**Environmental Monitor Construction Site Inspection Report  
MassDOT Project #608164 Construction Contract # 119678  
EM Report #16**

Project Description: Bruce Freeman Rail Trail Right-of-Way  
Permit Description(s): Order of Conditions (MGL Chapter 131, Section 40 and 310 CMR 10.00, Mass DEP File No. 301-1362); 2022 EPA NPDES General Permit for Discharges from Construction Areas; U.S. Army Corps of Engineers Permit No NAE-2021-01975.

Project Name:	Bruce Freeman Rail Trail - Phase 2d - Sudbury
Date of Inspections:	8/7/2024
Bi Weekly/ Monthly Period Covered:	August Weekly Inspection #2
Inspector's Name(s):	Anna Haznar
Inspectors' Contact Information:	<a href="mailto:ahaznar@beta-inc.com">ahaznar@beta-inc.com</a>

SUDBURY BRUCE FREEMAN RAIL TRAIL			
STATE	FED. AID PROJ. NO.	SRPT	10074
MA	CNGTAP/STP-0033026X	70	319
	PROJECT FILE NO.		608184
CURB & BASELINE TIE PLANS

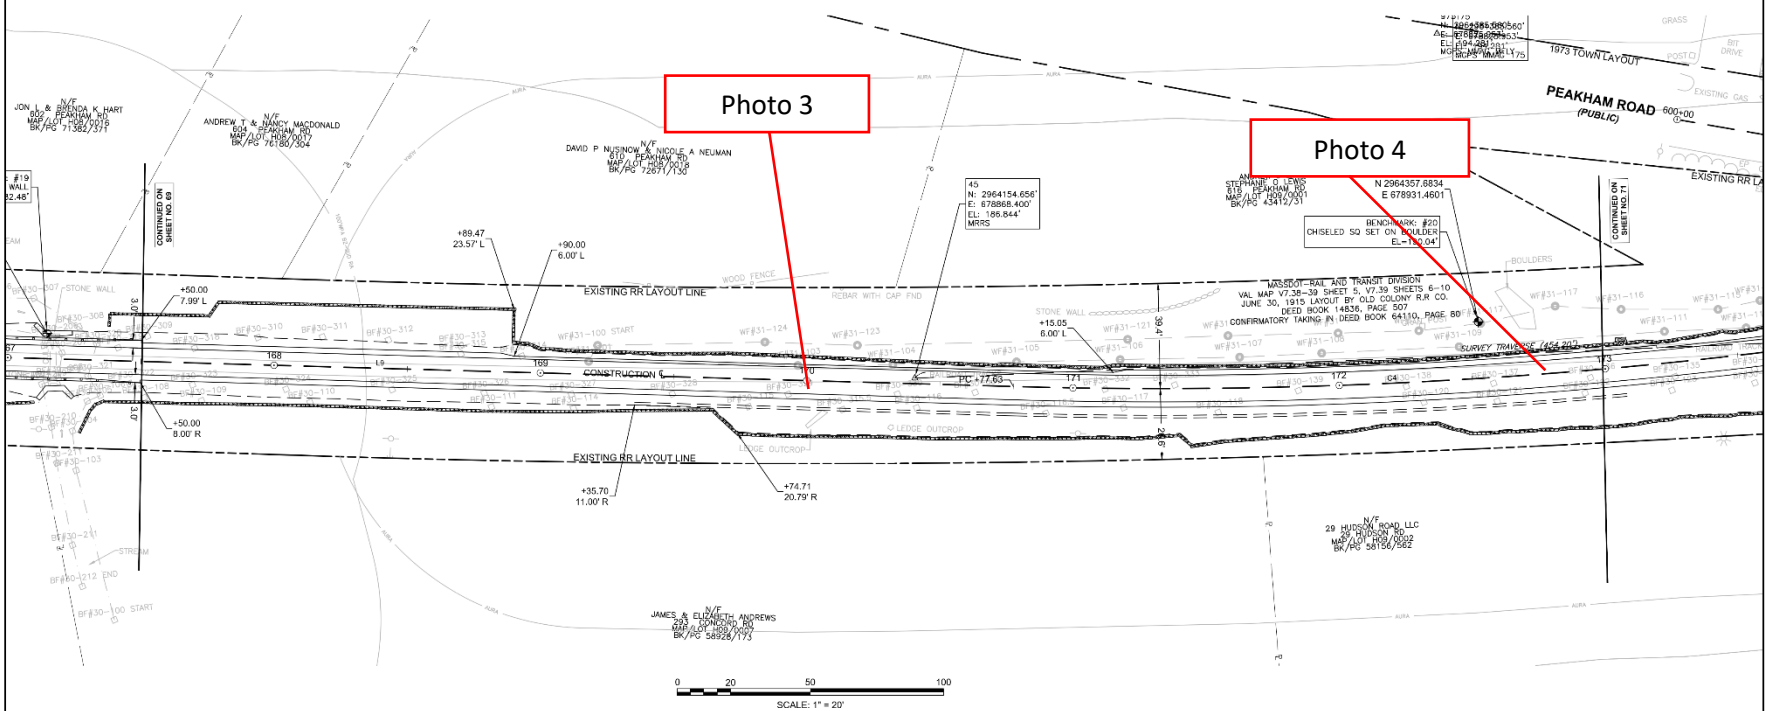
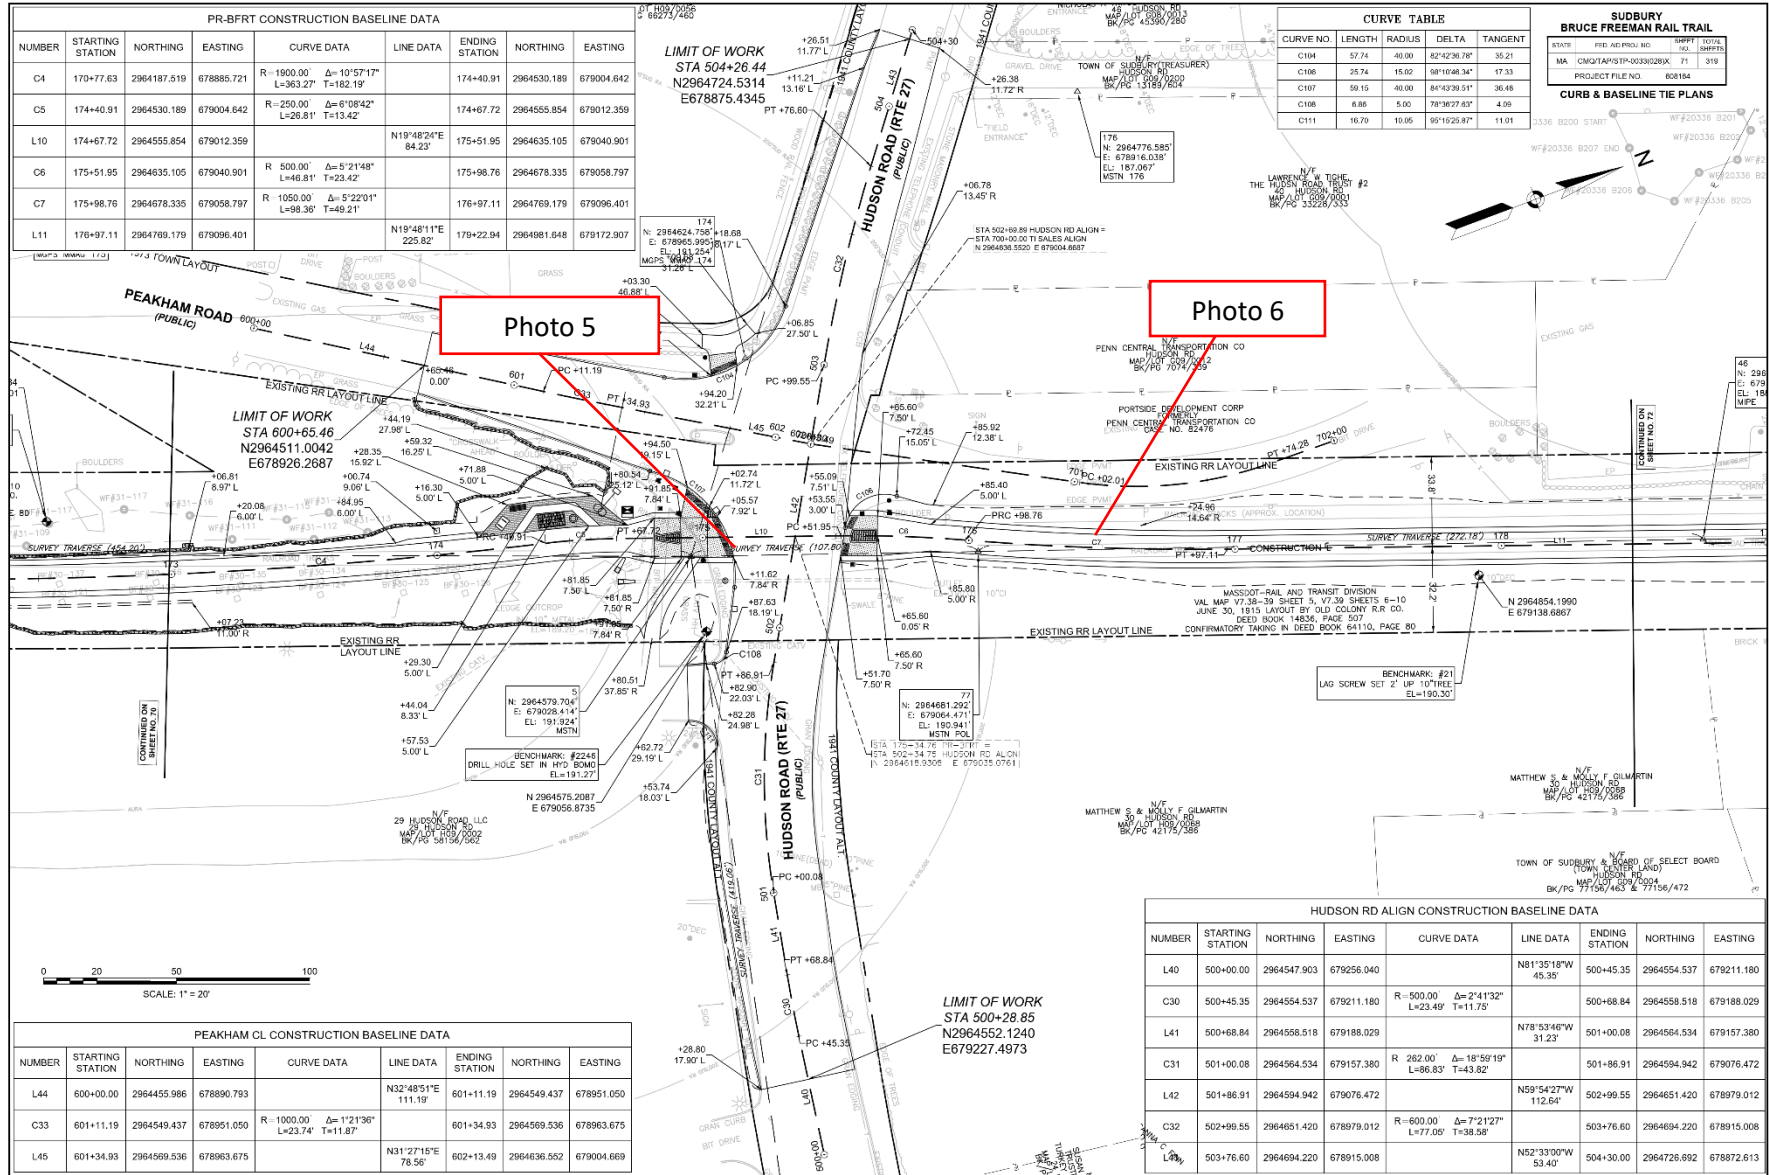
Item	Location/ Description	Observation Date	Resolution Due Date	Recommended Resolution / Resolution Date	Comments/Updates
56	Crushed stone discharged to the swale at Station 170+00 Priority: High	8/5/2024	8/12/2024	Remove crushed stone from swale and provide more robust erosion and sediment controls	8/7/2024 - Observation remains.
55	Crushed stone dust was observed requiring removal from the streambed on the west side of the path at Station 215+00 to 217+50 Priority: High	8/5/2024	8/12/2024	Remove crushed stone from streambed and provide more robust erosion controls	8/7/2024 - Observation remains.
54	Runoff associated with the stamped concrete splitter island was observed requiring removal from the streambed on the west side of the path at Station 216+00 Priority: High	8/5/2024	8/12/2024	Remove runoff from streambed and provide more robust erosion controls	8/7/2024 - Runoff was not visible within the streambed post-storm, but was still present downgradient and upgradient of erosion controls. Erosion controls at this location have been undermined and there is potential for more runoff to enter the streambed. This item will remain open until the material has fully hardened.

53	Stone was observed requiring removal from the swale on the east side of the trail at Station 172+00 to 173+00 Priority: High	7/29/2024	8/6/2024	Remove stone from the swale.	8/5/2024 - Observation remains. 8/7/2024 - Observation remains.
52	Slope along the driveway to the parking lot at Station 216+50 requires stabilization Priority: Medium	7/29/2024	8/6/2024	Install erosion control blanket and place seed.	8/5/2024 - Observation remains. 8/7/2024 - Observation remains.

688164\_F01CURBS & BASELINE TIE PLANS(DWG) Printed on 27-Jun-2023 10:08 AM

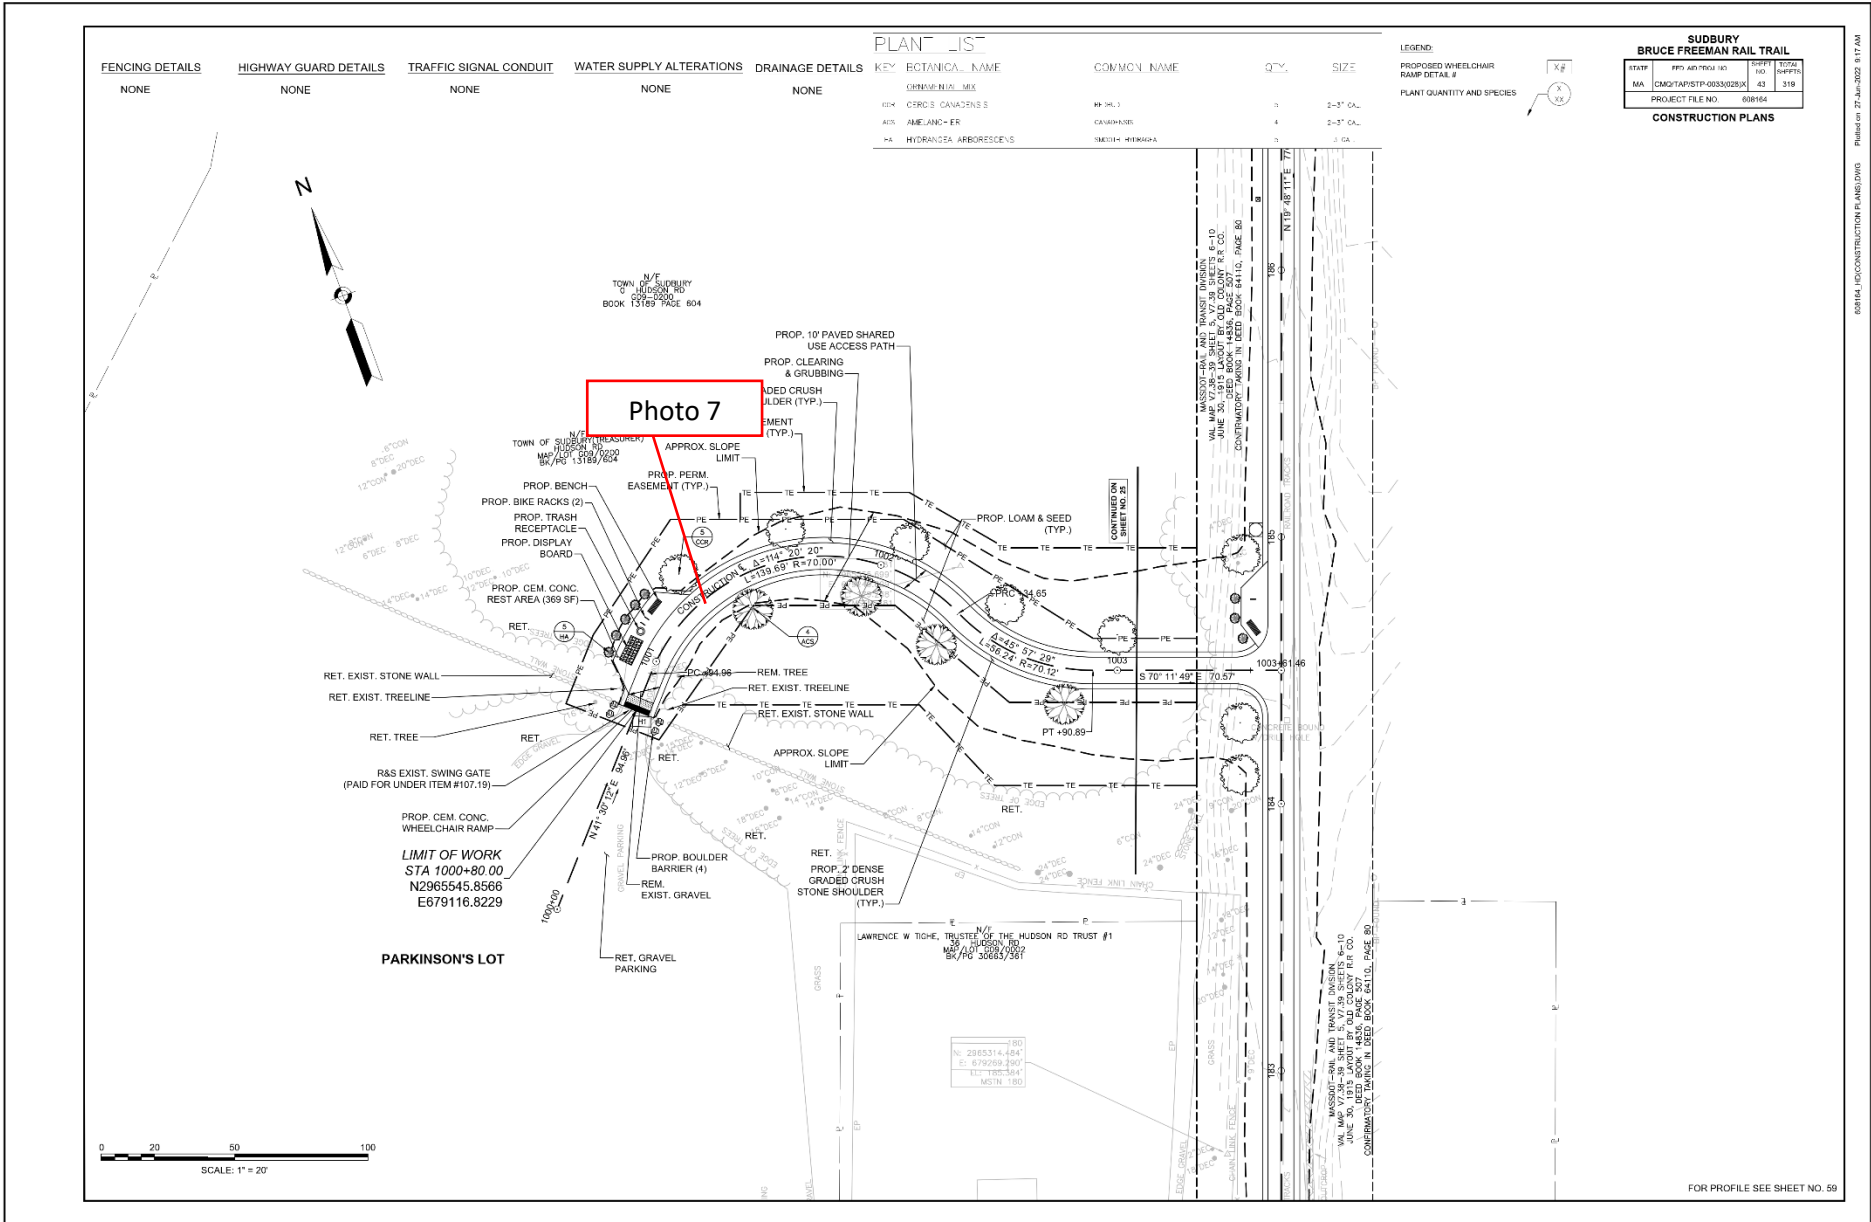
41	Stream Bank has been regraded beyond the limit of work at Station 216+00 Priority: High	5/28/2024	6/4/2024	The Contractor should confirm if this work was permitted by the Conservation Commission, as it does not appear to be a part of the approved plans/impacts. MassDOT should be consulted on next steps regarding notification and potential restoration.	5/31/2024 - Observation remains. 6/7/2024 - Observation remains. 6/14/2024 - Observation remains. 6/17/2024 - Observation remains. 6/24/2024 - Observation remains. 6/27/2024 - Observation remains. 7/8/2024 - Observation remains. 7/15/2024 - This area could not be assessed due to paving operations ongoing during the inspection. 7/22/2024 - Crushed stone and sediment continue to be discharged to the stream between Stations 215+00 and 217+00 due to overtopped and undermined compost filter tubes. 7/29/2024 - Observation remains. 8/5/2024 - Observation remains. 8/7/2024 - Observation remains.
